#### **76.2.2.5.2 Variables**

Modify Figure 77-31 in subclause 77.3.6.1 GATE description

Figure 77-31—GATE MPCPDU: (a) normal GATE MPCPDU, (b) discovery GATE MPCPDU

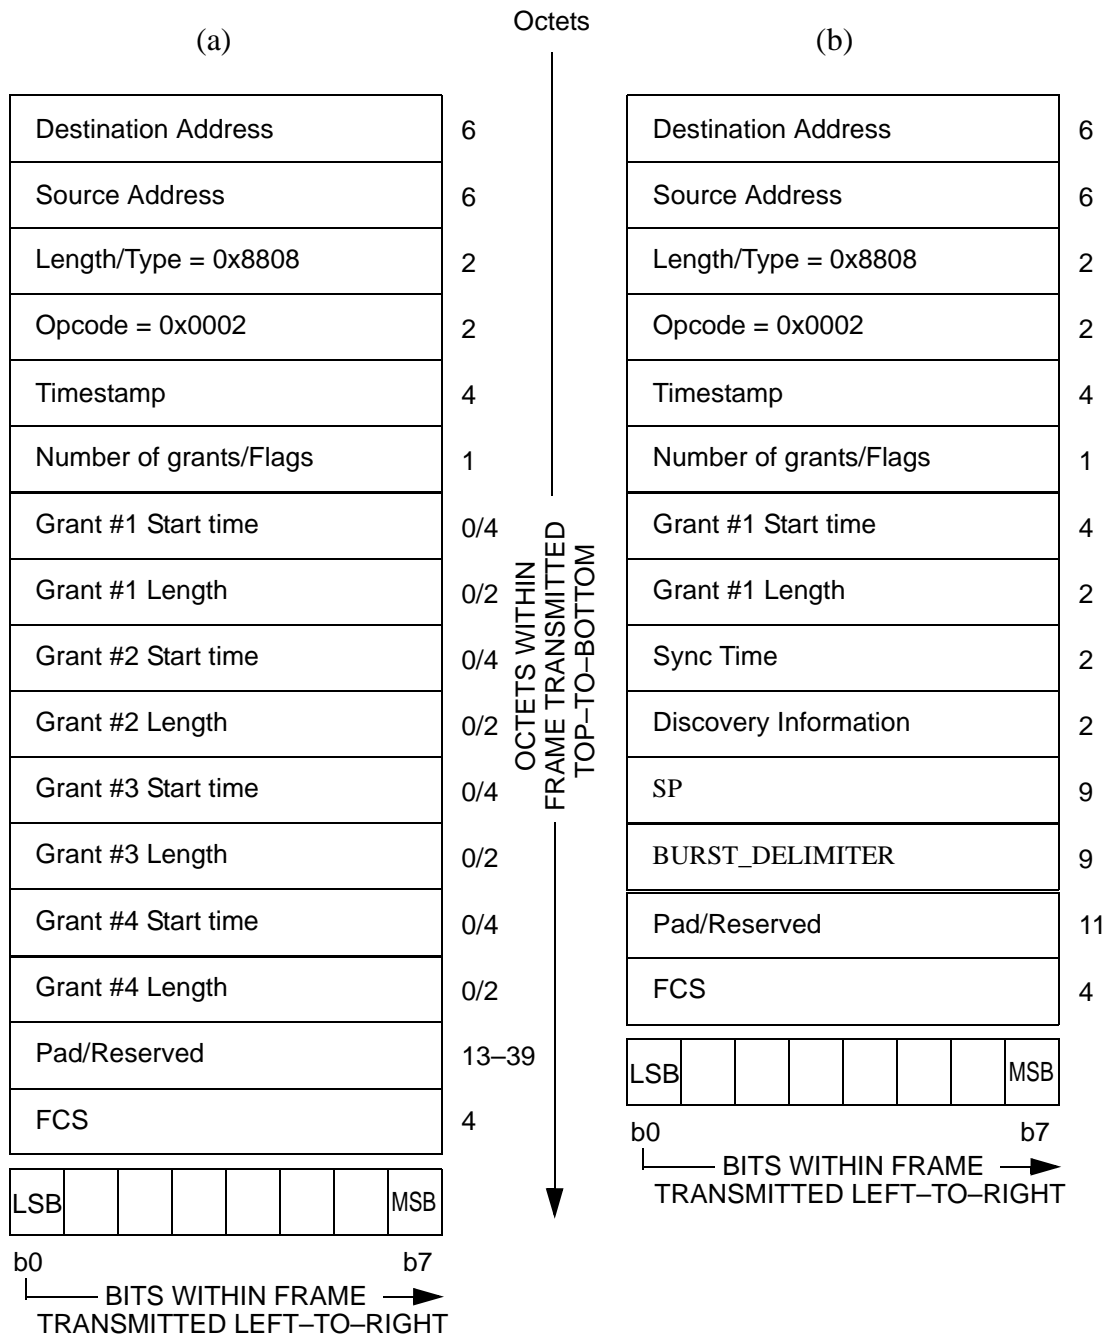
Add tables describing SP and BURST\_DELIMITER to subclause 77.3.6.1 GATE description.

**Table 77–xx—GATE MPCPDU SP Fields**

Bit	Values
0-65	Sync pattern to be used in the upstream direction.
66-71	Ignored on reception.

**Table 77–yy—GATE MPCPDU BURST\_DELIMITER Fields**

Bit	Values
0-65	BURST_DELIMITER to be used in the upstream direction.
66-71	Ignored on reception.
